MEMORANDUM
	TO:	Town of Belleair Planning and Zoning Board, and Mayor and Town Commission
Building Code Services	FROM:	Christopher Brimo, AICP Calvin, Giordano & Associates
Coastal Engineering		Carvin, Giordano & Associates
Code Enforcement	THEOLOGI	
Construction Engineering and Inspection	THROUGH:	Micah Maxwell, ICMA – CM Town Manager
Construction Services		
Contract Government	SUBJECT:	Preliminary Site & Development Review for Property
Data Technologies and Development		Located at 1501 Indian Rocks Road, and Application for Variances to the Following: Yard Setback Requirements;
Emergency Management Services		Landscape Buffer and Tree Mitigation; Joint Use Parking
Engineering		and Off-Street Loading Zones, By Pelican Golf Club LLC
Environmental Services		(Dan Doyle), on behalf of the Town of Belleair (Owner)
Facilities Management		
Indoor Air Quality	DATE:	March 13, 2017
Landscape Architecture

This application is a site plan and redevelopment proposal for the Pelican Golf Club located at 1501 Indian Rocks Road; Parcel No. 28-29-15-68247-000-0002. The applicant intends to purchase the property from the Town of Belleair and make several site improvements relating to the buildings,

> > FIGURE 4. LANDSCAPE STANDARD A

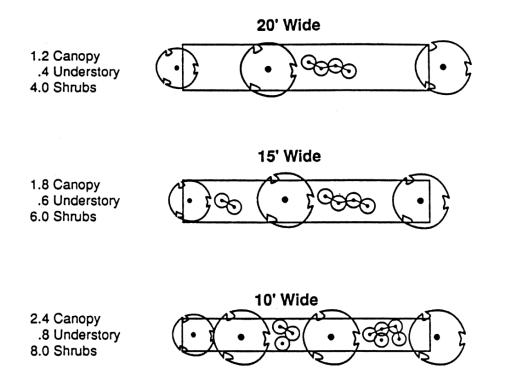
Golf course structures (GC) abutting R-1, RM-15 and P zoning districts shall adhere to landscape standard "A", as illustrated below. The applicant's redevelopment proposal for the "Golf Club parcel" meets the requirements for buffering. Although the applicant intends to preserve all vegetation along the project boundaries and adjacent to residential properties, the remainder of the golf course would not meet the buffer requirements in some areas. Strict interpretation of the Code requirement could effectively create a visual screen between the golf course and the surrounding residential properties.

Additionally, the variance must include the areas where the applicant believes that that "intent of the buffer requirements" is being met. The intent of the code as it specifically relates to landscaping is found in 66-6 (3), which has been attached. Staff also feels that it is important to consider that in some cases the cart path has been moved closer to the border between the course and the homes along the course, which may increase cart golf traffic at a closer proximity to those homes.

The applicant is therefore requesting a variance to the landscape buffer requirements Section 74-232(b)(4), for those areas of the golf course that currently do not meet the requirement. It is again recommended that the board consider Policy 1.1.4 of the Future Land Use Element of the Comprehensive Plan, which
